**Bastrop County Precinct 2 Road and Bridge Facility Construction**

**RFB 25BCP04J**

**ADDENDUM #2**

Addendum #2 provides clarification and answers from questions submitted by contractors and has an updated drawing and specification package as some aspects of the project have changed. Bastrop County is extending the due date for submissions until June 4, 2025, at 2:00PM. The new deadline for questions concerning the scope of work is May 27, 2025, at 5:00PM. Below is a list of documents that are included in Addendum #2:

# 2

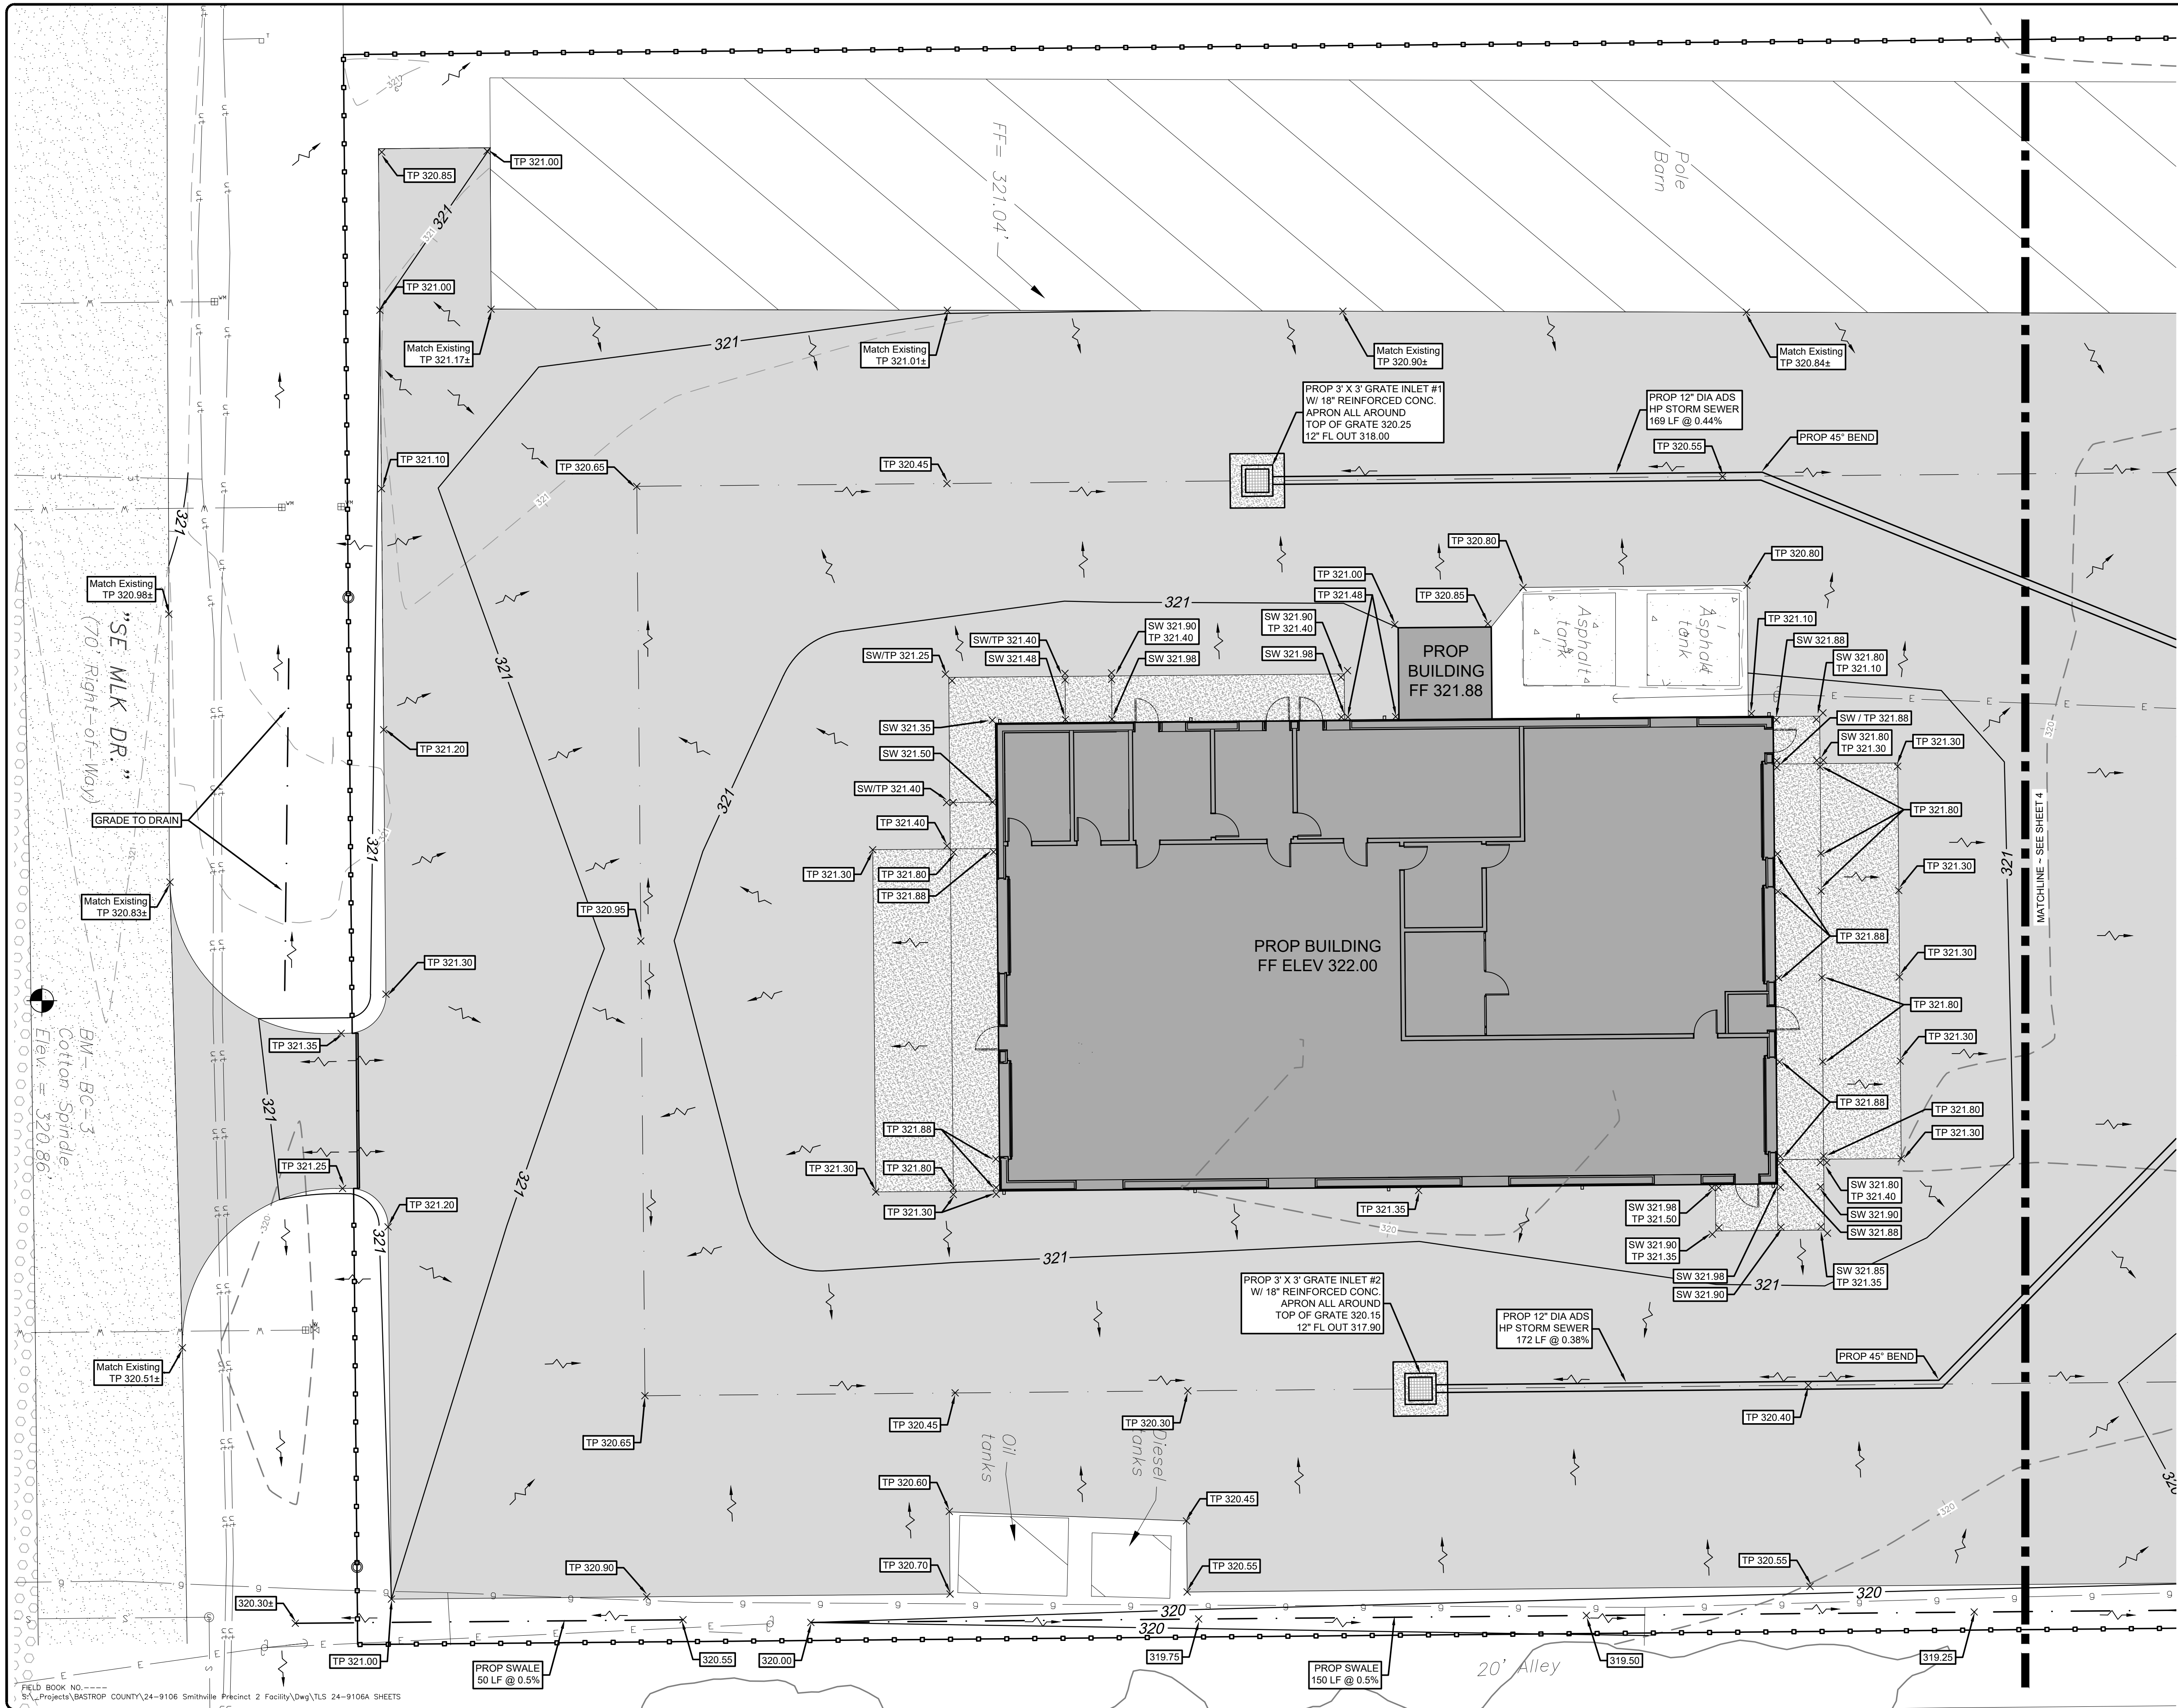
***Comment 7 (Sheet 2): Eliminate bend in sanitary sewer service and connect directly from cleanout to manhole.***

***Comment 8 (Sheet 2): Do we know anything about this existing sanitary sewer manhole in which the proposed service will be tying into (i.e. age, condition, rehab necessary?, new penetration?, etc.)***

***Comment 9 (Sheet 2): 20' – 0" on graphical scale.***

***Comment 10 (Sheet 2): Provide 9 feet separation between water and sanitary sewer service.***

SHEET  
 A005

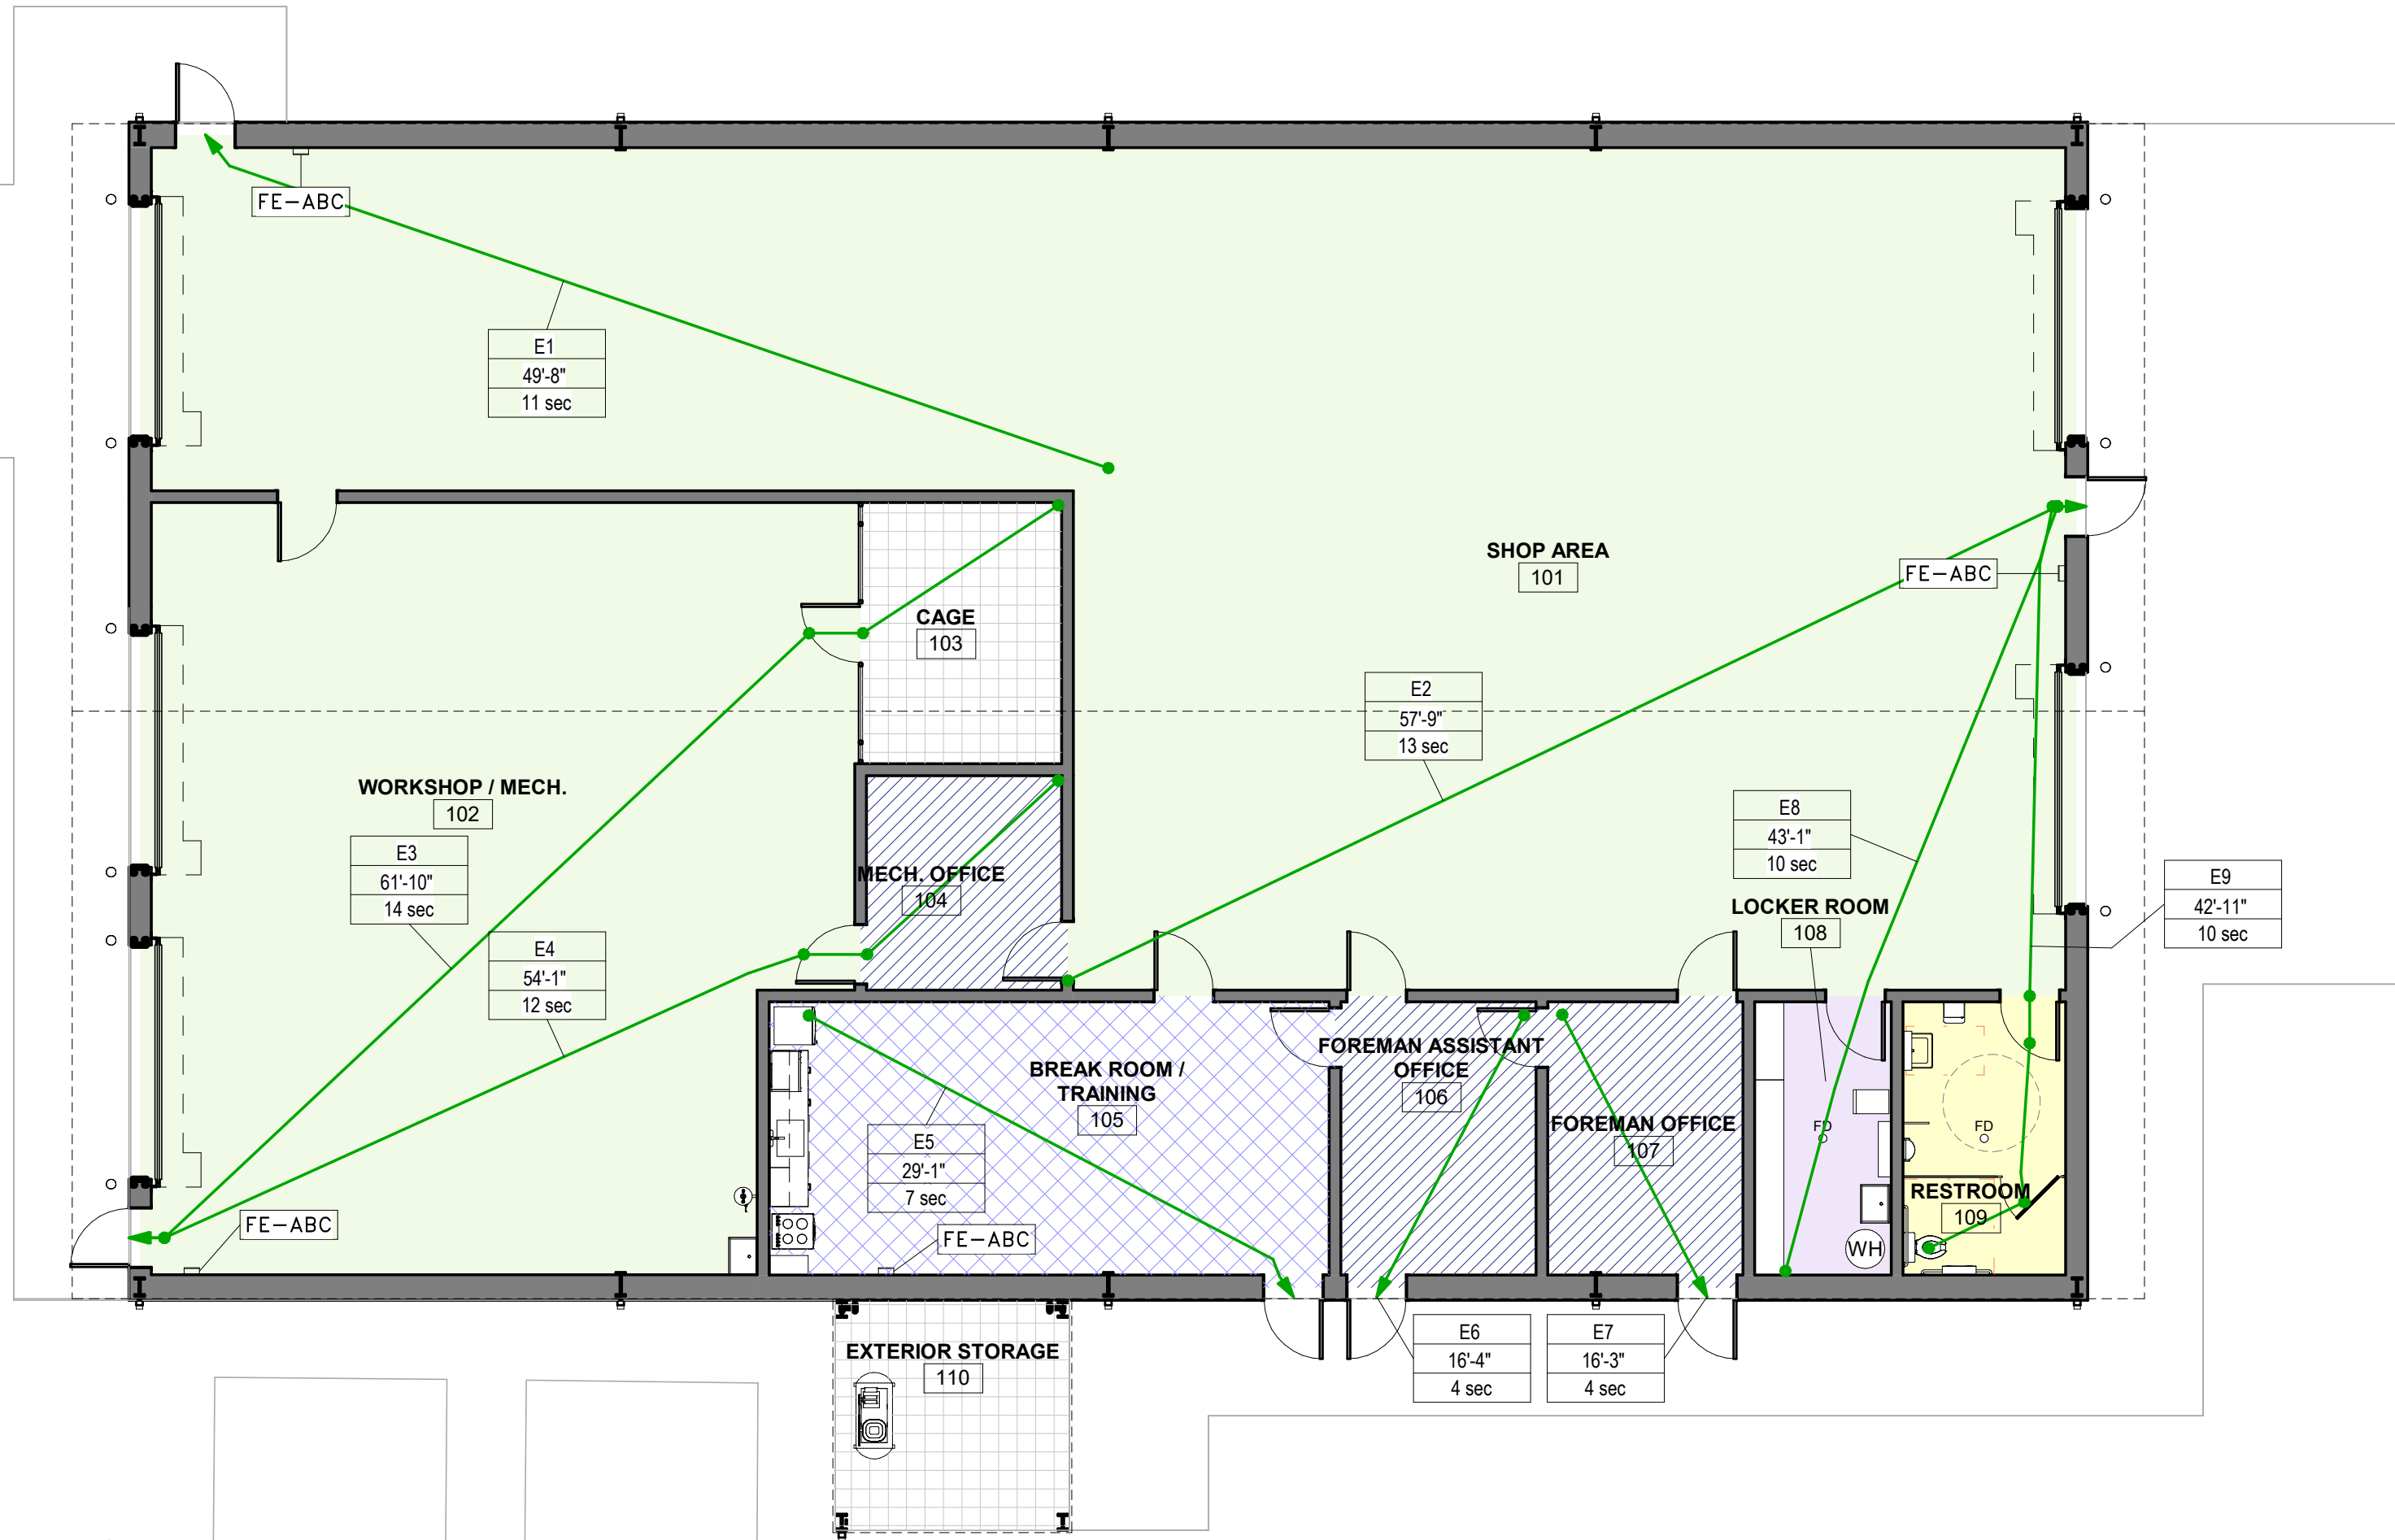
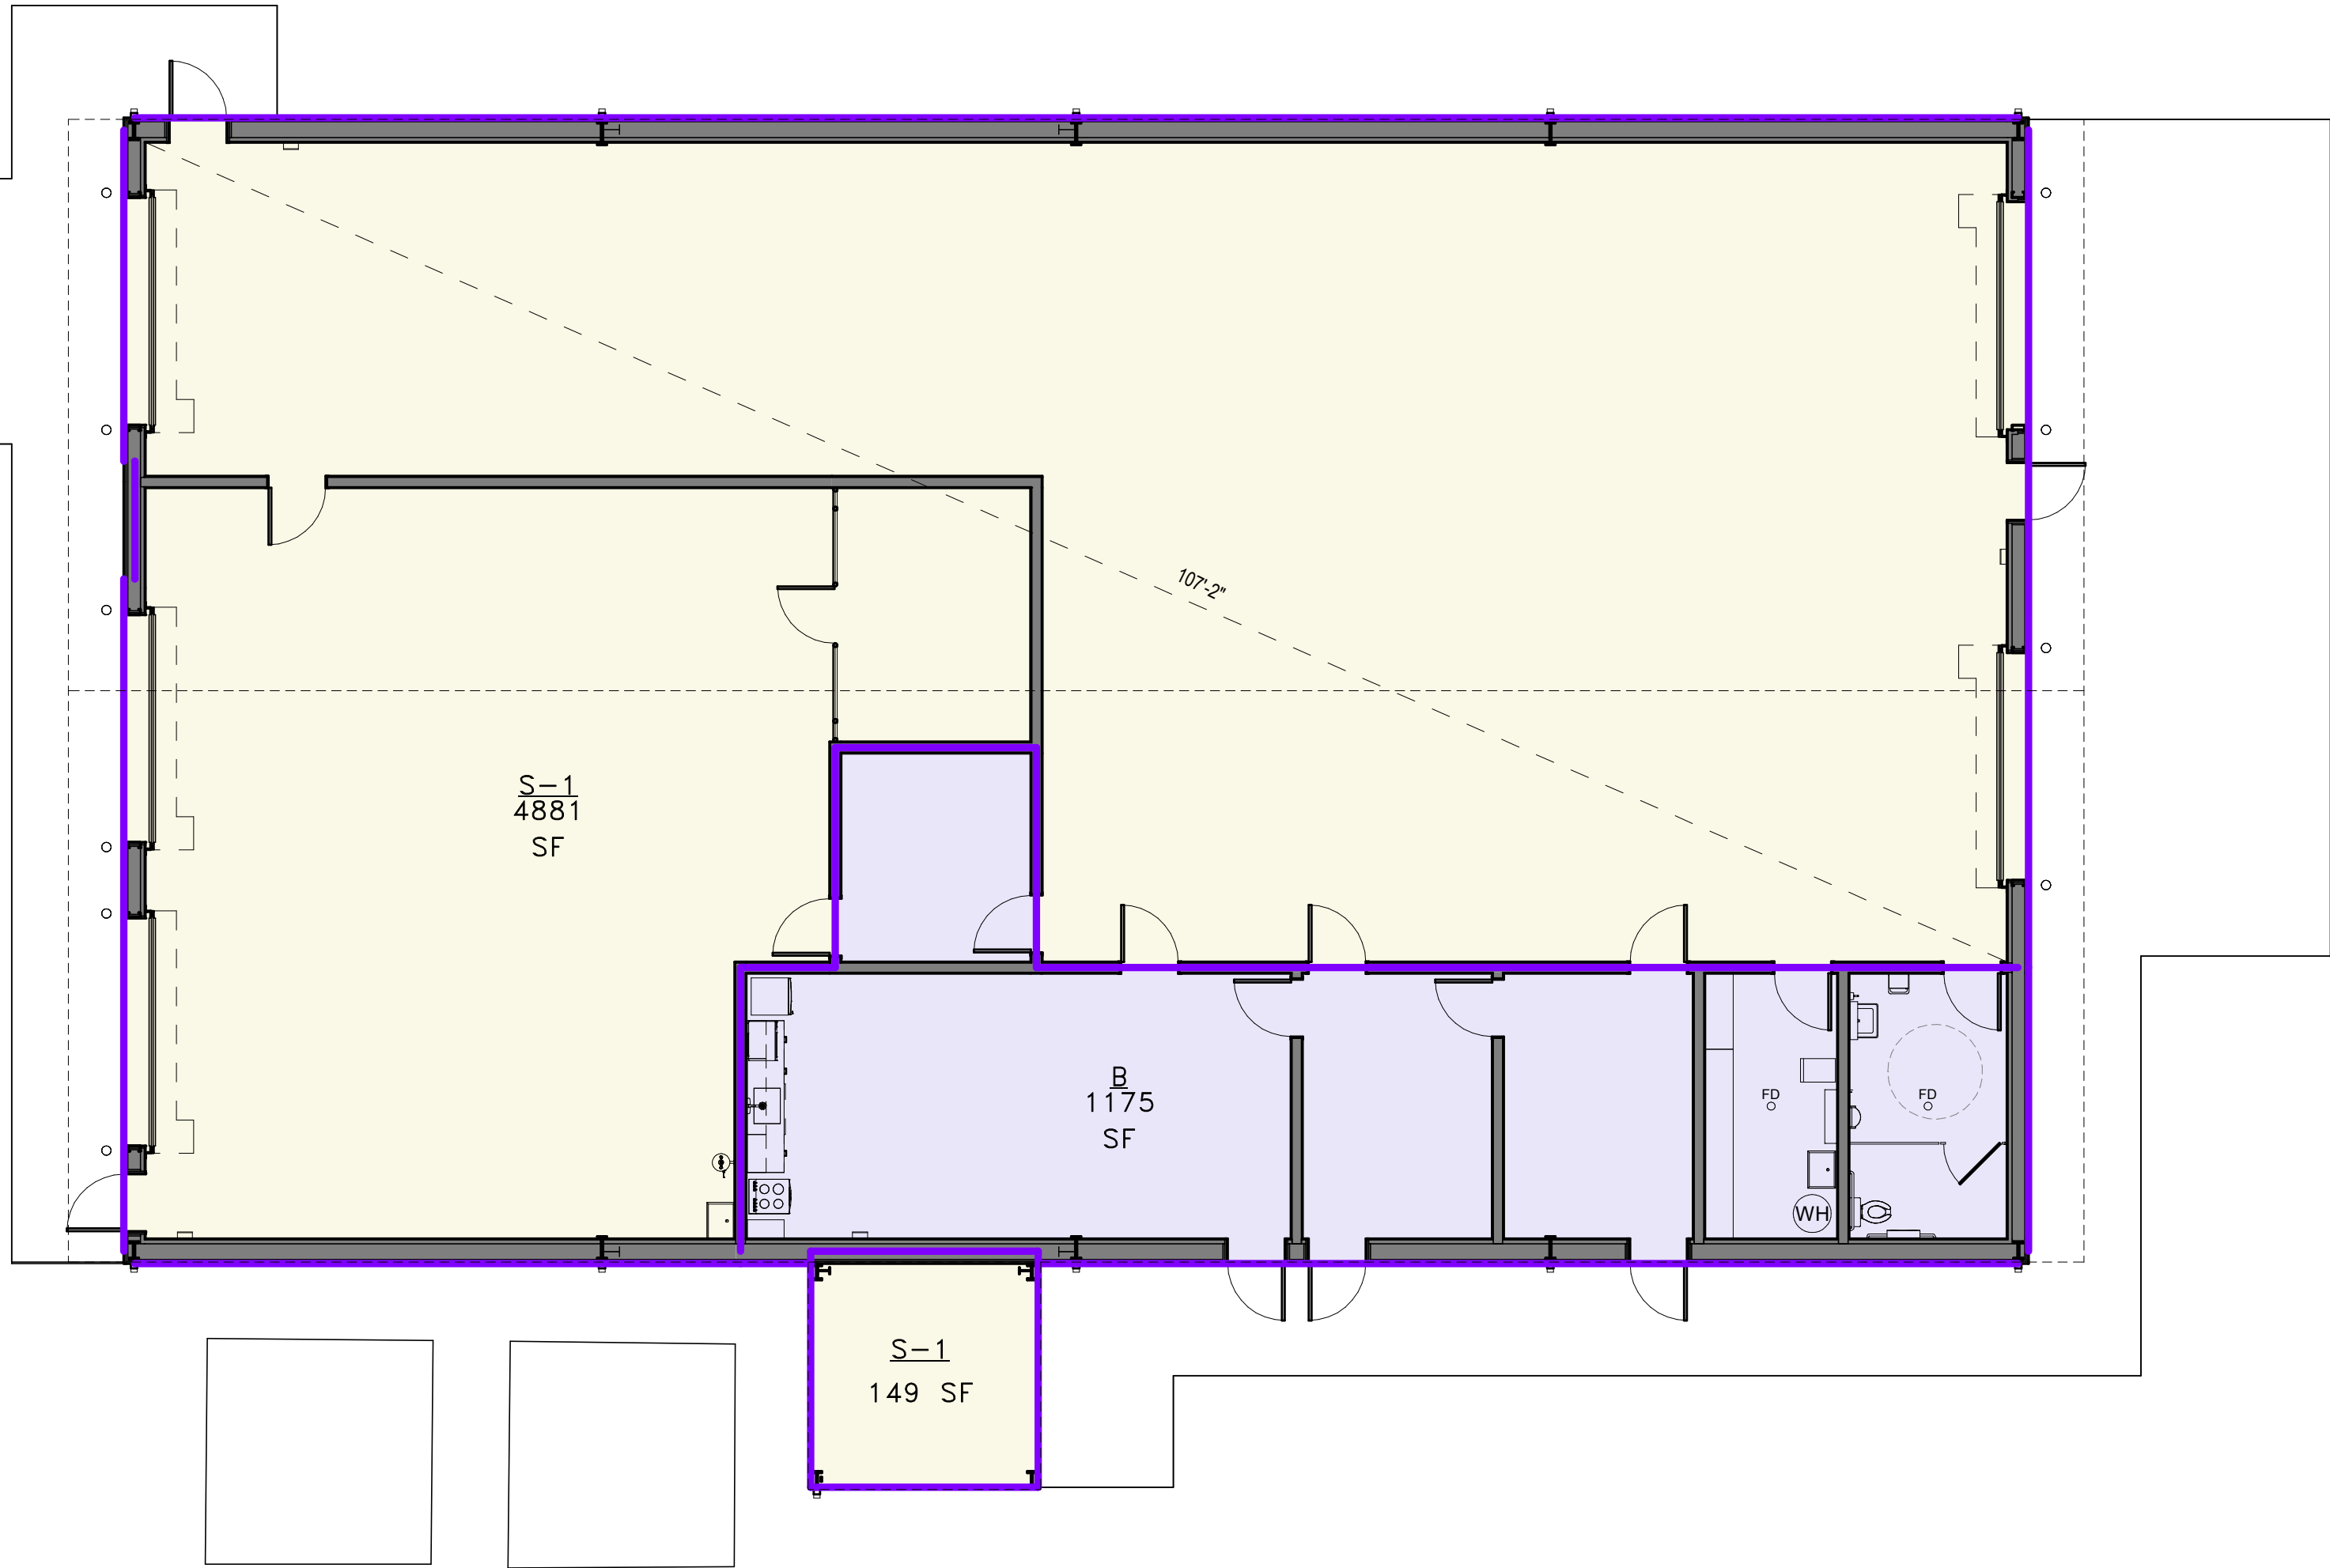
*2. Sheet A006 - The occupancy load table is not completed and currently shows the occupancy load as zero.*

*3. Sheet A006 - Though the occupant load has not been provided on the plans, it's clear based on the uses provided for the spaces the occupancy load exceeds 15.*

CasaBella Architects Response: Refer to revised sheet A006 Code Study

CasaBella Architects Response: Refer to revised sheet A006 and attached written letter from Owner no more than 15 occupants will occupy the building.
